# Work Order ID 74250

Item Name: Crosstube Turning Detail

DRAWING NO. D212-664-147	TITLE CROSSTUBE ASS'Y (205 LOW FWD)	REV. B	<b>DART AEROSPACE LTD ENGINEERING ORDER</b>		D.E.O. NO. D212-664-147-B-1	SHEET NO. SHEET 1 OF 1	SCALE NTS
DRAWN <i>Q</i>	CHECKED <i>ASS</i>	MFG. APPR. <i>VB</i>	APPROVED <i>MD</i>		DE APPR. <i>HT</i>		
DATE 11.07.15	DATE 11.07.20	DATE 11.07.21	DATE 11/07/21		DATE 11.07.21

REPLACE MAGNOBOND WITH PROSEAL.

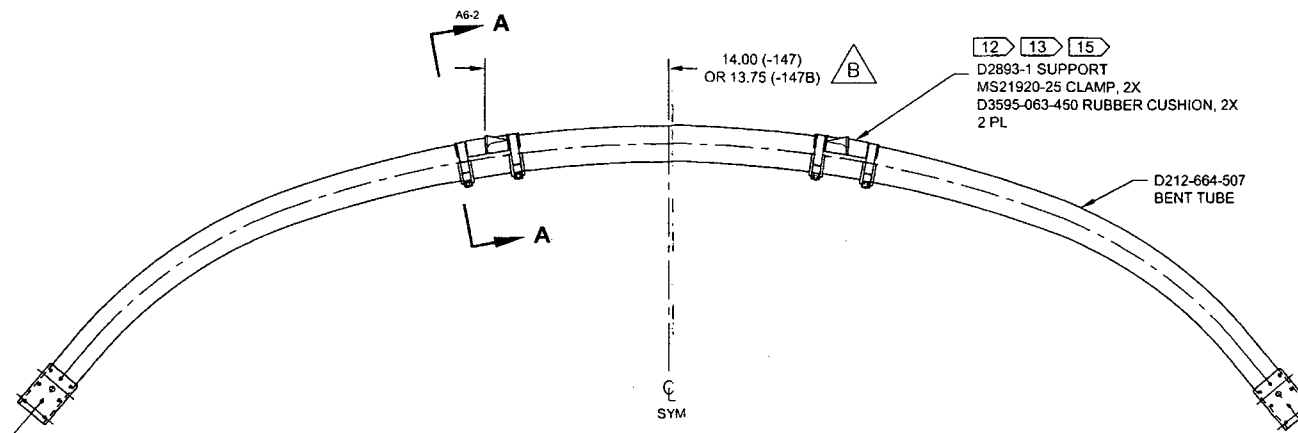
NOTE 12 & 15, SHEET 1 IS AMENDED AS FOLLOWS:

- 12) TO INSTALL D2893-1 SUPPORT: ABRAD MATING SURFACE OF SUPPORT AND CROSSTUBE WITH 180-GRIT SANDPAPER AND REMOVE RESIDUE WITH MEK (OR EQUIVALENT). APPLY A 0.04" TO 0.07" THICK LAYER OF PROSEAL 890 CLASS B-2 (OR AMS-S-8802 CLASS B-2) SEALANT TO MATING SURFACE OF SUPPORT.
- 15) TORQUE CLAMPS 80 TO 100 IN-LB. ENSURE AT LEAST 1.5 THREADS SHOWING IN SAFETY AND THAT NUT HAS NOT BOTTOMED-OUT AFTER TORQUING. **PRIOR TO PACKAGING, RE-CHECK TORQUE ON CLAMPS AFTER PROSEAL 890 SEALANT HAS CURED FOR 72 HOURS.**

**D212-664-147/-147B**  
**ASSEMBLY DETAIL**

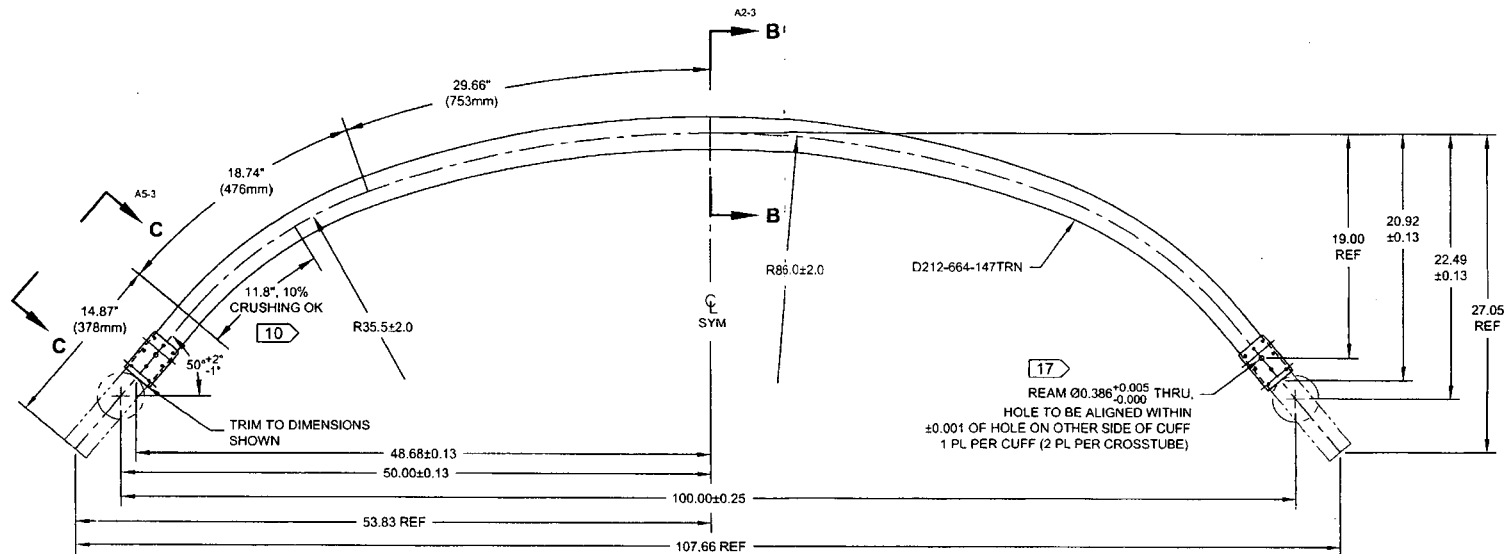
APPLY MAGNOBOND  
BETWEEN D2893-1 AND  
CROSSTUBE
